SOUTH COAST AIR QUALITY MANAGEMENT DISTRICT

Draft Staff Report

Proposed Amended Rule 218.2 – Continuous Emission Monitoring System: General Provisions

Proposed Amended Rule 218.3 – Continuous Emission Monitoring System: Performance Specifications

Figure 1: Dual Range Analyzer Monitoring Gap

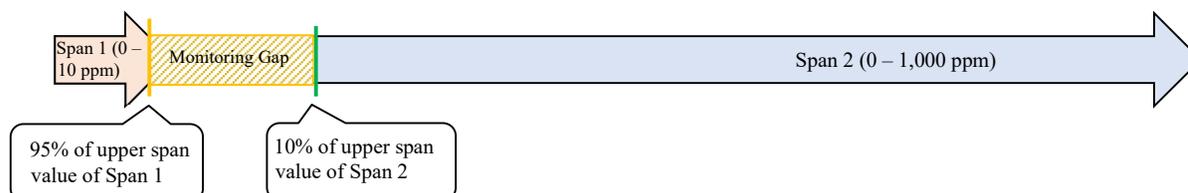
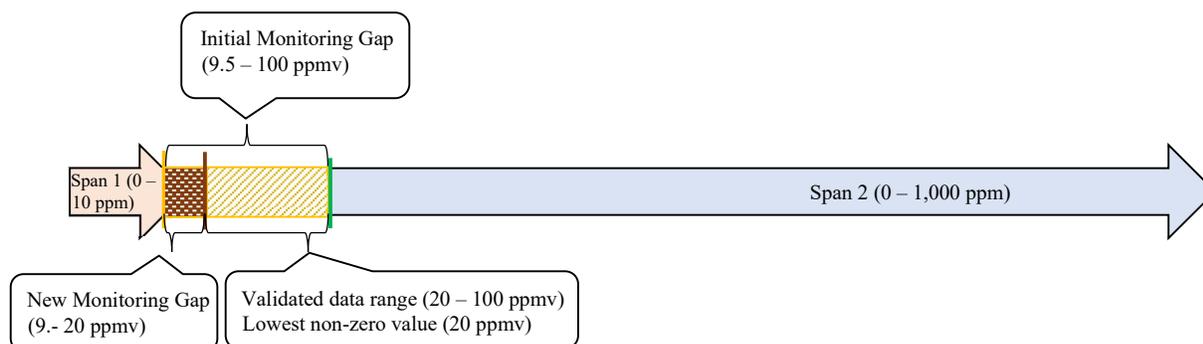
1. AES supports the addition of the proposed Low-Level Linearity Performance Test (LLLPT) as a method to quality assure data falling in the "Monitoring Gap" between 95% of a lower span range and 10% of an upper span range. However, the current PAR 218.3 requires a Low-Level Calibration Error (LLCE) test in addition to the LLLPT despite the acceptance criteria of the LLLPT being significantly more stringent. The table below shows reference gas concentrations and allowable error for both tests based on the example contained in the PAR 218.2/218.3 Revised Preliminary Draft Staff Report dated June 2022. For the span ranges in the example, the allowable error of the LLLPT expressed in parts per million (ppm) is as low as 1 ppm while the allowable error for the LLCE is 25 ppm. Therefore, AES believes that with the requirement of the LLLPT the LLCE test is unnecessary for quality assuring the "Monitoring Gap" between ranges. AES requests that the LLCE test requirement be removed for ranges other than the lowest vendor guaranteed span range.

3. The current PAR 218.3 Section (i)(2)(B)(i) is inconsistent with the changes proposed in Section (i)(1)(C). AES recommends Section (i)(2)(B)(i) be updated in accordance with the proposed change to Section (i)(1)(C).

- Response 4-1:** Staff agrees with the commentor and has updated the proposed rule language to not require longer LLCE test requirements for ranges other than the lowest vendor guaranteed span range.
- Response 4-2:** Staff agrees and updated Table A-2 to include the term “Nominal Concentration at 10% of Span Range Tested.”.
- Response 4-3:** Staff agrees and revised Rule 218.3 clause (i)(2)(B)(i) to be consistent with the proposed revision to Rule 218.3 subparagraph (i)(1)(C).
- Response 4-4:** Staff agrees and incorporated the commentor’s suggestion.
- Response 4-5:** To clarify the requirement, staff has included the sentence “any hour without sufficient valid data points required by subparagraph (i)(4)(A)” to provide more specificity for the hours requiring a data substitution.

Figure 4: Startup Missing Data Procedure for Unit not Frequently Shutdown

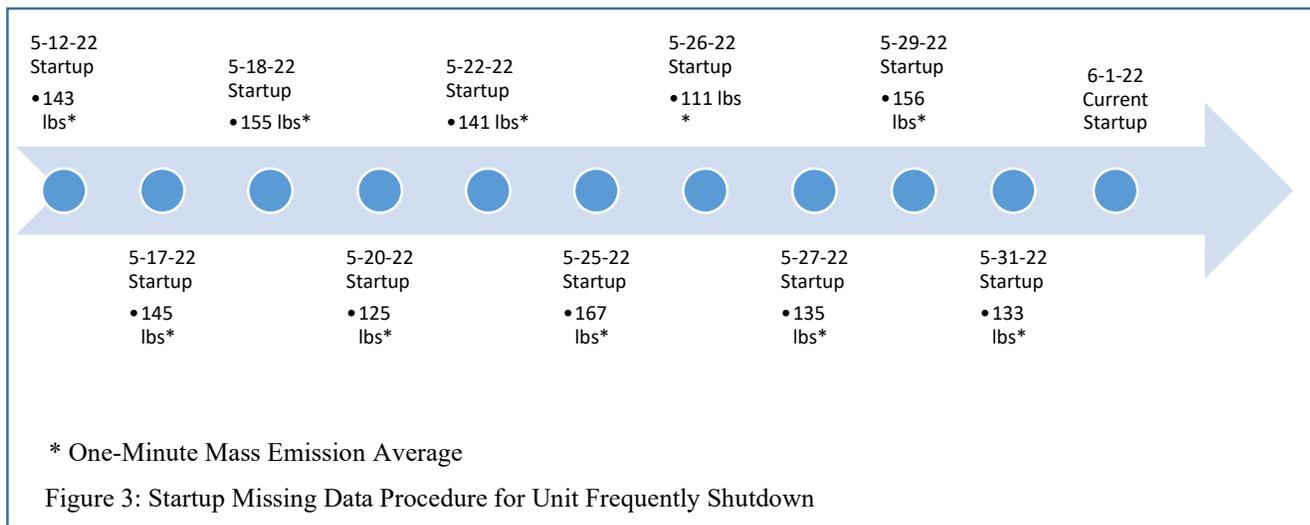
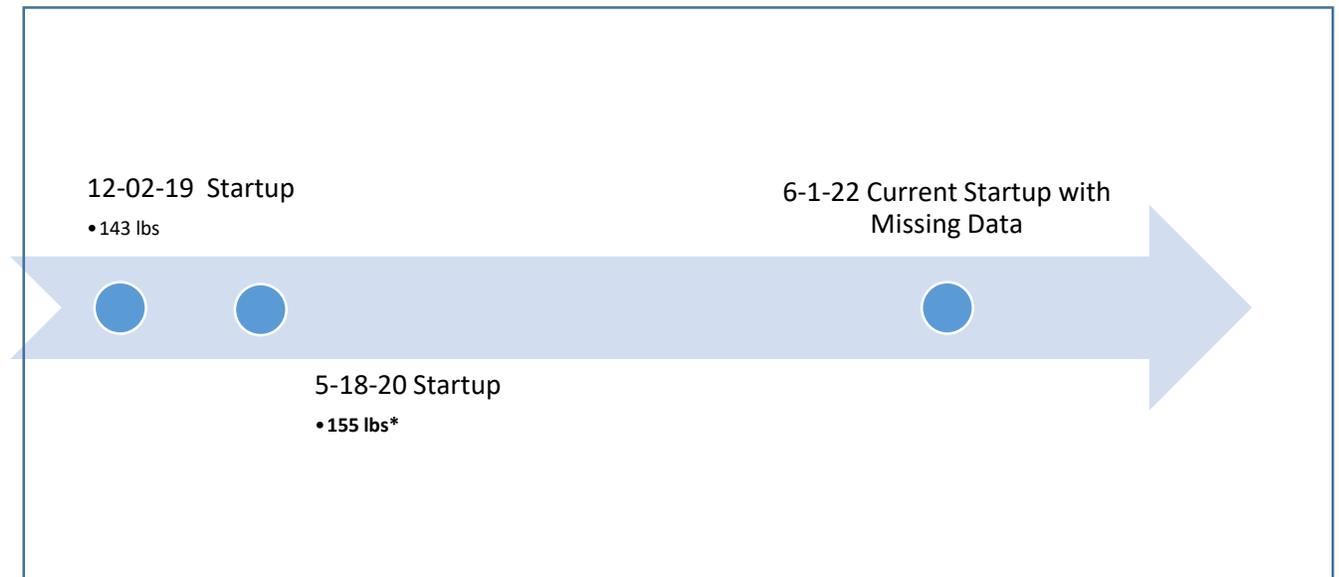
4. The current PAR 218.3 Section (i)(13)(C) requires data substitution using data from previous completed startups or shutdowns if a startup or shutdown has more than fifty percent of missing 1-minute mass emission data. AES requests the “completed” startups or shutdowns in this rule section to be revised to “successfully completed” startups or shutdown, so that data from completed but non-representative startups or shutdowns due to equipment breakdown issues would be excluded from emission calculations.
